Recall Campaign

NHTSA #: 11V-251 TC #: 2011-166

Remove and replace stabilizer jack bolts

EAGLE SUPER LITE TRAVEL TRAILER

Manual Stabilizer Jack applications

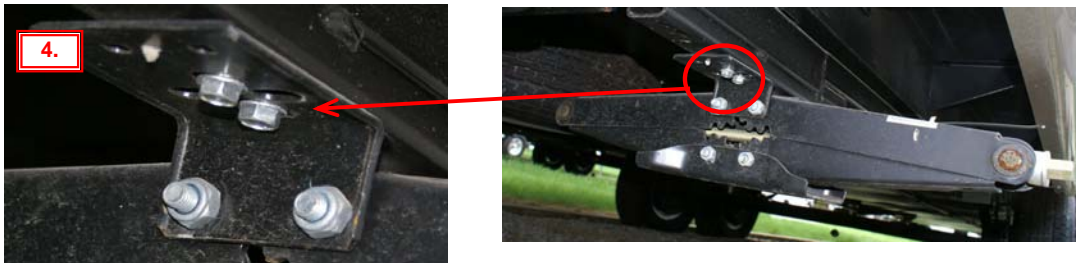
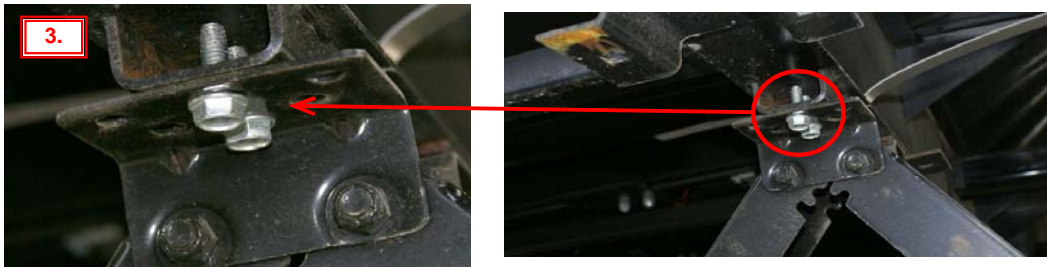
1. Remove (all) existing stabilizer jack bolts and replace with the bolts and washers (where applicable per pictures) supplied in the kit.

Electric Stabilizer Jack application

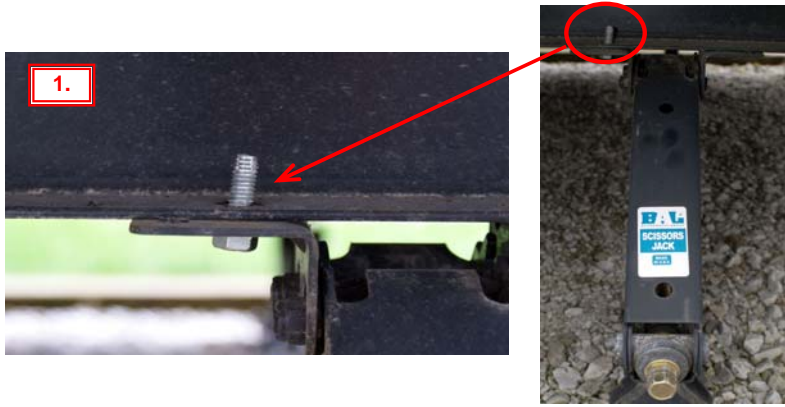
1. On the electric jack application, (2) additional bolts will need to be added. Drill (2) 9/32" holes in the frame rail bracket slot.

NOTE: Before drilling you will need to determine the best location for the holes. You will need to avoid any existing slots in the frame rail. Examine the frame rail to locate the slots and drill the hole so it will miss them. You will need a sharp drill bit to drill through the frame.

Install (2) bolts and washers in the newly drilled holes. Replace the existing bolts with those supplied in the kit. Re-use the original washers. (See Fig. 5)

Drill a hole and install additional (2) bolts and washers. Replace existing bolts (reuse the original washers)
